- VACUUM BREAKER 620243 HAS BEEN REPLACED BY NEW TYPE CODE 620535. BEFORE INSTALLING NEW VACUUM BREAKER FIRST CHANGE Ø21 TO Ø27

1526503

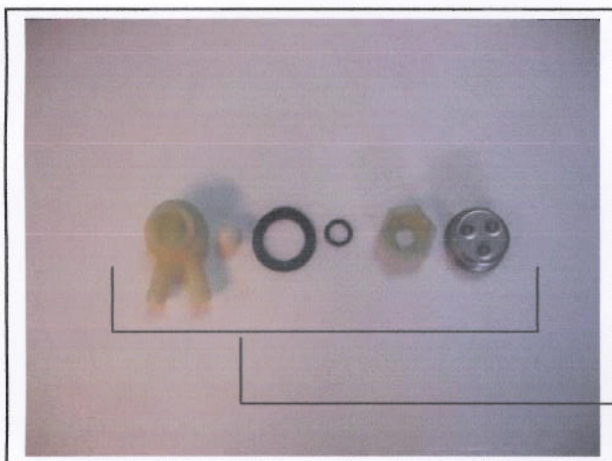
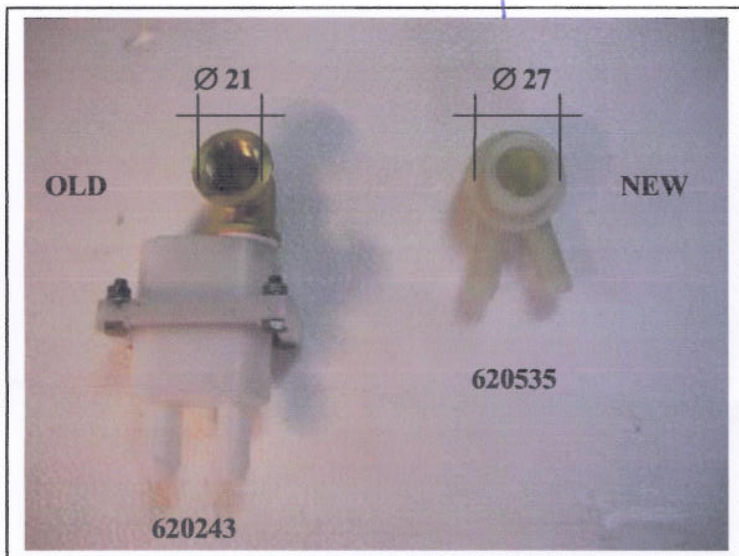
- LA VALVOLA ANTIVUOTO 620243 E' STATA SOSTITUITA CON IL NUOVO TIPO COD. 620535. PER IL MONTAGGIO ALLARGARE IL FORO DA Ø21 A Ø27

- ROHRTRENNER KODE NR.620243 ERSETZT DURCH KODE NR 620535. FÜR MONTAGE DAS LOCH BIS ZU Ø27 ERWEITERN

- LE CODE 620243 (CLAPET ANTIVIDE) A ETE REMPLACE PAR CODE 620535. POUR LE MONTAGE EVASER LE TROU JUSQU' A Ø27
